**GNWT Response to:  
WRRB IR#1**

Caribou (boreal and barren-ground) – Application of Assessment Endpoint and Measurement Indicators

EA1617-01 Tłıchǫ All-Season Road Information Request Responses from GNWT

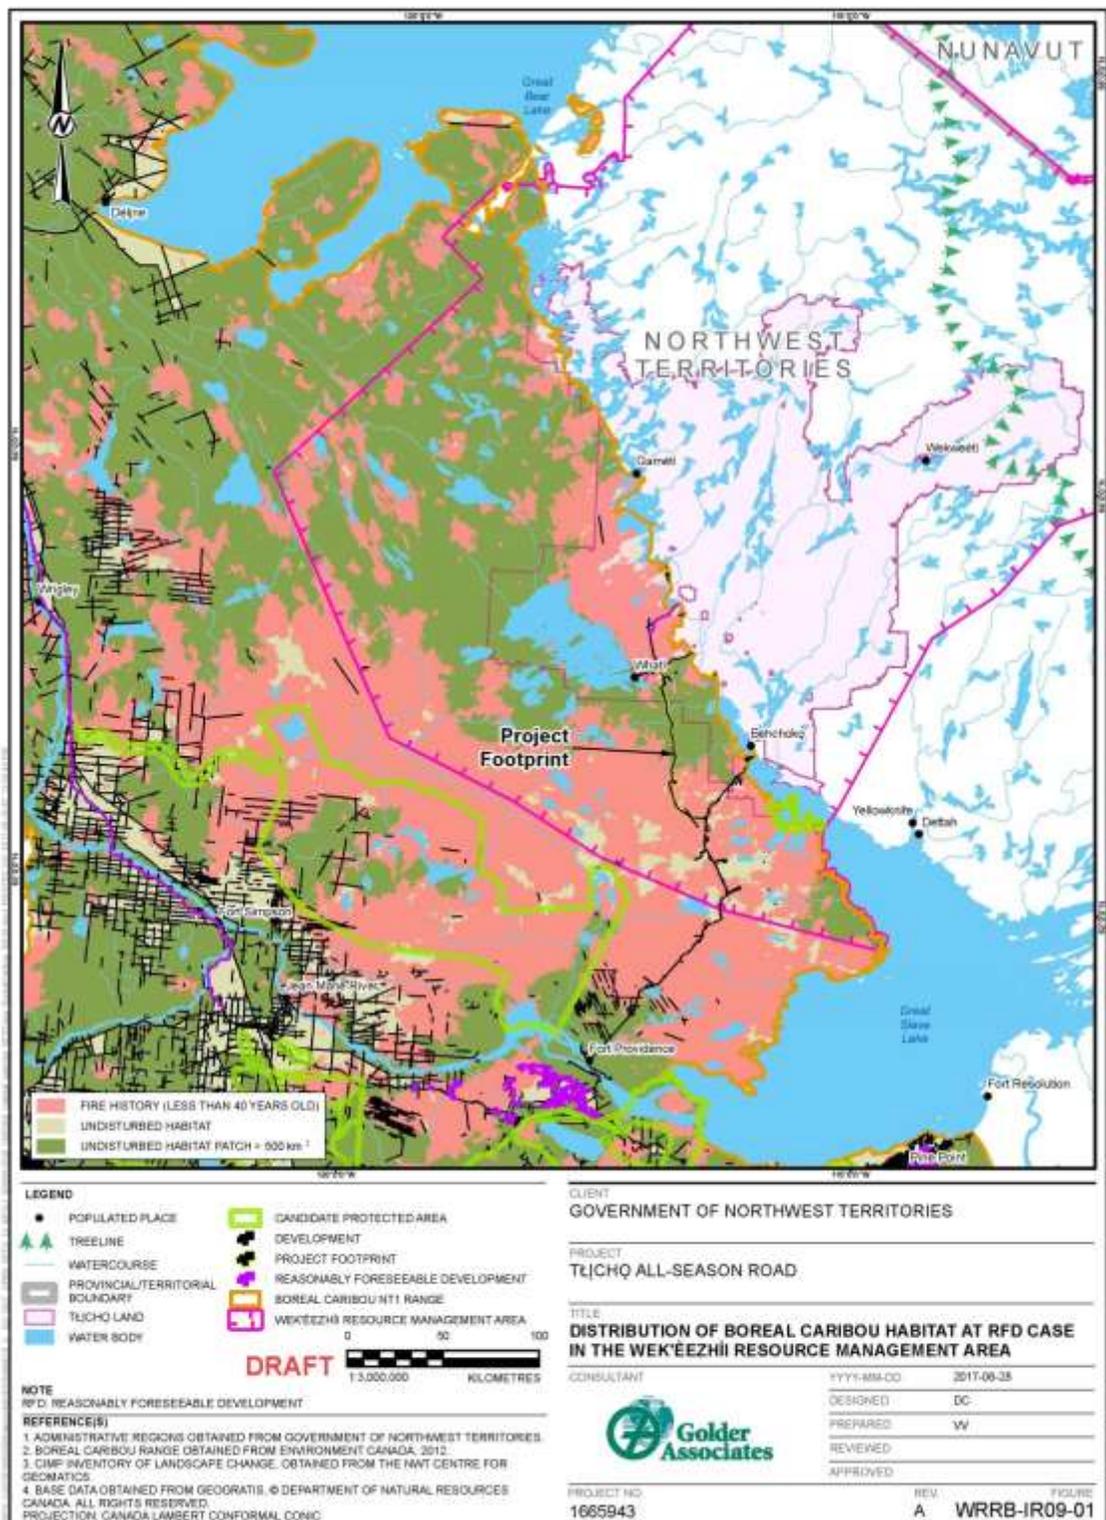
1. Provide a qualitative assessment of the patch sizes including a frequency distribution of the patch sizes of secure unburnt habitat in Wek'èezhì (refer to methods outlined in Nagy 2011 regarding patch size classes) and provide a map

of Wek'èezhì which clearly shows the spatial arrangement of secure unburnt habitat patches (>500km<sup>2</sup>) relative to the TASR corridor;

The distribution of boreal caribou habitat in the Wek'èezhì Resource Management Area portion of the NT1 range in the RFD Case is provided in **Figure WRRB-IR09-01**. Of the total amount of undisturbed habitat present in Wek'èezhì portion of the NT1 range in the RFD Case, the majority is classified as undisturbed habitat patches greater than 500 km<sup>2</sup>. Patches of undisturbed habitat less than 500 km<sup>2</sup> occur primarily in the southern portion of the Wek'èezhì Resource Management Area, south of the location of the Project (**Figure WRRB-IR09-01**). As identified in the response to ECCC IR#6, the Project would result in no change in the distribution of large patches of undisturbed habitat because it overlaps an existing linear disturbance. Habitat patches greater than 500 km<sup>2</sup> on either side of the Project would be maintained after the application of the Project and RFDs (**Figure WRRB-IR09-01**).

Several undisturbed habitat patches within the NT1 range that are greater than 500 km<sup>2</sup> span the western boundary of the Wek'èezhì Resource Management Area (**Figure WRRB-IR09-01**). Thus, boreal caribou present in the Wek'èezhì Resource Management Area have the ability to use large connected patches of undisturbed critical habitat outside of the Wek'èezhì Resource Management Area boundary to meet survival and reproductive requirements and interact at a population level with other caribou in the NT1 range. Therefore, the Wek'èezhì Resource Management Area boundary does not contain a biologically discrete caribou population.
